Product Change Notification (PCN)

PCN #: 7C-2019

Laird Part Number	Old Rev	New Rev	Description
001-0002	1	2	Antenna, Dipole, 900 MHz, 50ohms, 2dBi, 13mm x 196mm, RP SMA, Black, Swivel

5.1 Antenna Markings

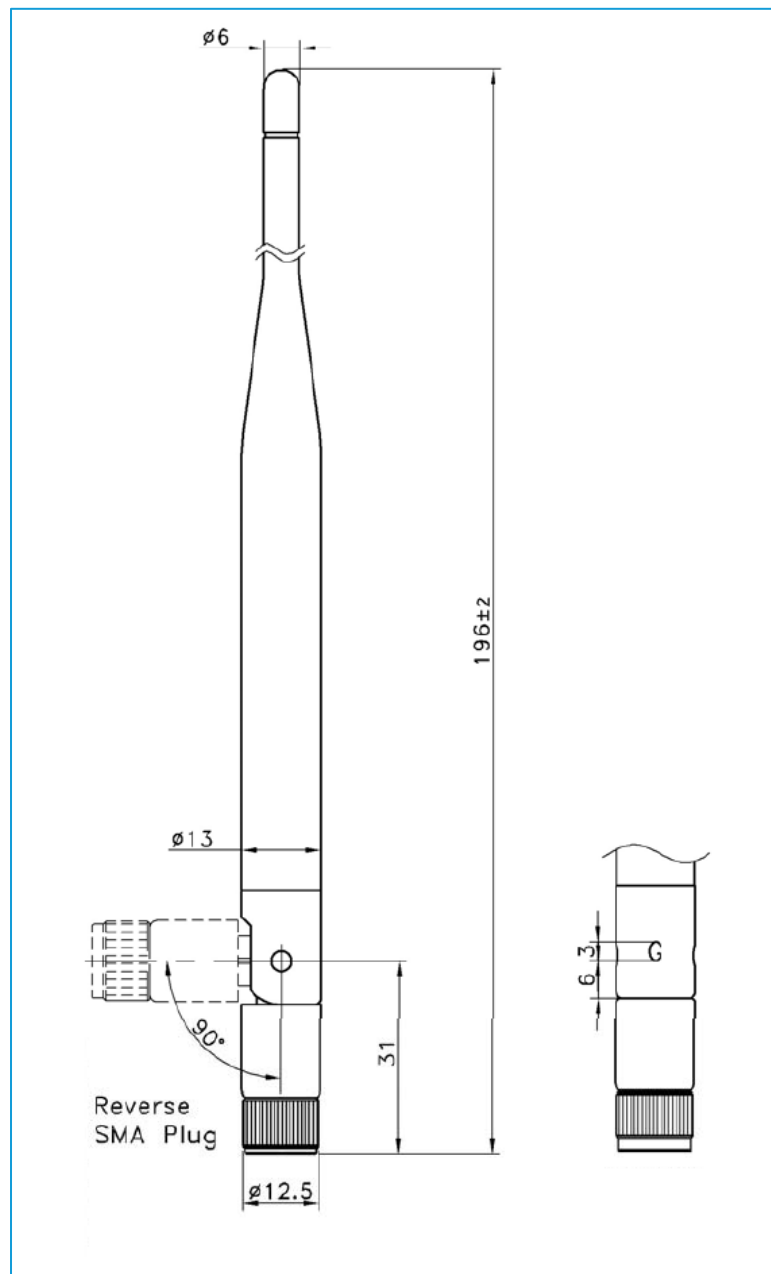
- A letter 'G' will be laser-etched into the lower base of the antenna to identify the latest rev of the antenna. Dimensions in mm.
